**RE:** **216 South J Street**

**TITLE:** **HRPB Project Number 22-00100239:** Consideration of a Certificate of Appropriateness (COA) for window, door, and siding replacement for the single-family house located at 216 South J Street; PCN# 38-43-44-21-15-087-0090. The subject property is a contributing resource within the Southeast Lucerne Historic District and is located in the Low-Density Multi-family (MF-20) zoning district. The future land use designation is Medium Density Residential (MDR).

**Exhibit A: Existing Windows and Proposed Windows**

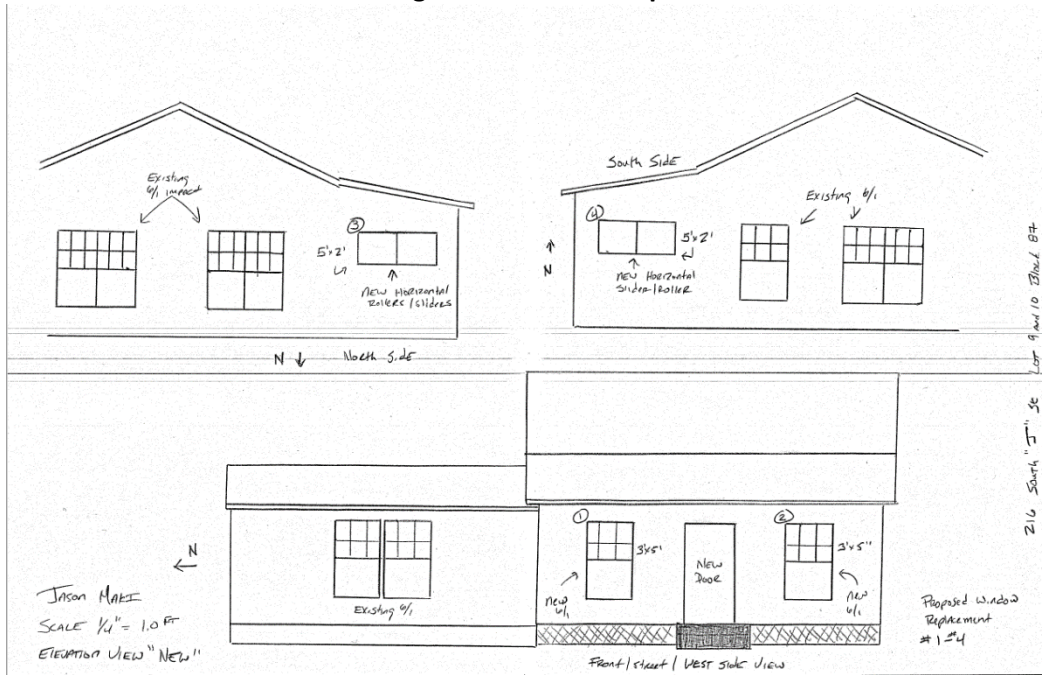
**STAFF RECOMMENDATION:** Staff is recommending denial of the proposed horizontal roller and/or awning windows (#1 and #4) based on the requirements in the Historic Preservation Design Guidelines. Staff recommends changing the proposed horizontal roller or awning windows to six over one single hung windows to match the existing and proposed six over one single hung windows.

**Staff Analysis:** The window replacements are depicted in the applicant’s drawings (see attachments). Based on the City’s Historic Preservation Design Guidelines, staff contends that the proposed horizontal roller or awning replacement windows are not appropriate replacements for the architectural style.

- 1) Replacement windows shall be six over one configuration to match existing windows on the rest of the house.
- 2) New window trim, sills, and mullions shall match original, subject to staff review at permitting.
- 3) The replacement door shall be a door that is consistent with styles identified for Wood Frame Vernacular architecture in the Design Guidelines subject to staff approval at permitting.
- 4) The windows and door shall be recessed within the wall and shall not be installed flush with the exterior wall.
- 5) All divided-light patterns shall be created utilizing exterior raised applied muntins. Exterior flat muntins or “grills between the glass” shall not be permitted.
- 6) All siding repairs shall match the original in shape, size, profile, and configuration.

**Exhibit B: Existing Windows**

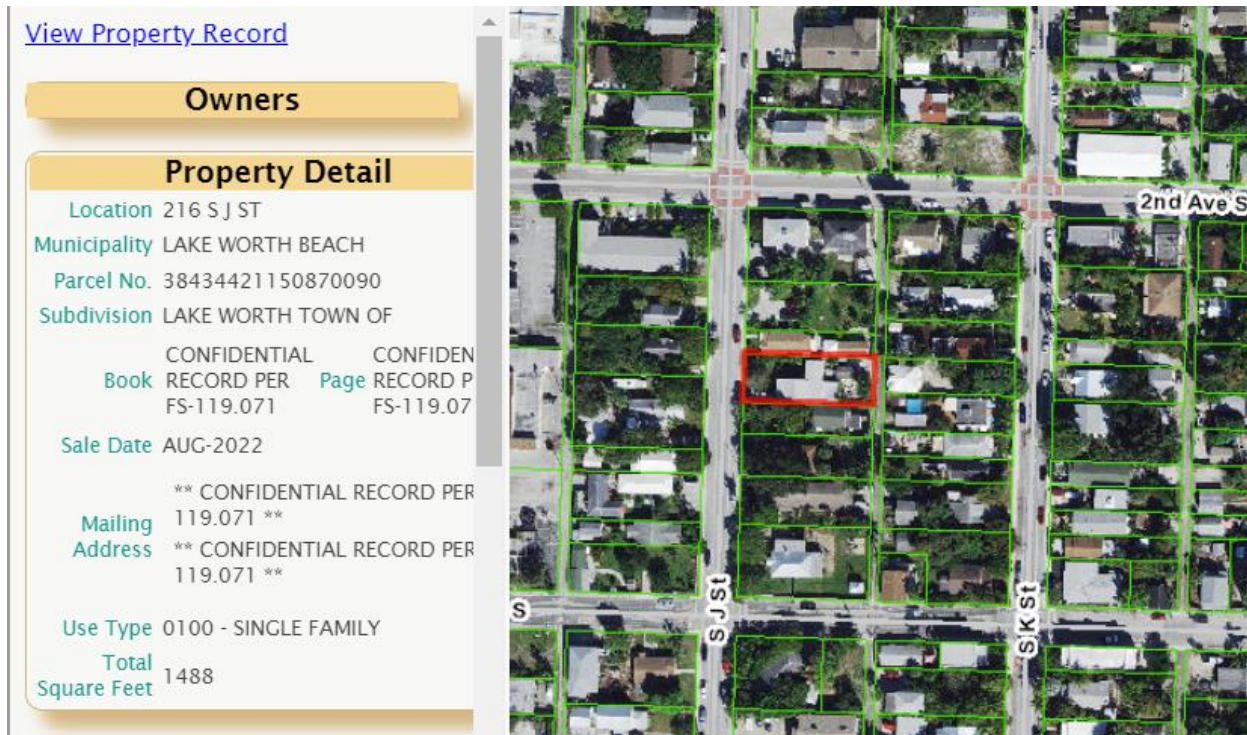
**Staff Analysis:** Per the regulations set forth in the City’s Historic Preservation Design Guidelines, replacement windows shall replicate the appearance of the original windows. While the six over one single hung windows are appropriate replacements for the original windows, the proposed horizontal roller or awning windows are not appropriate replacements.
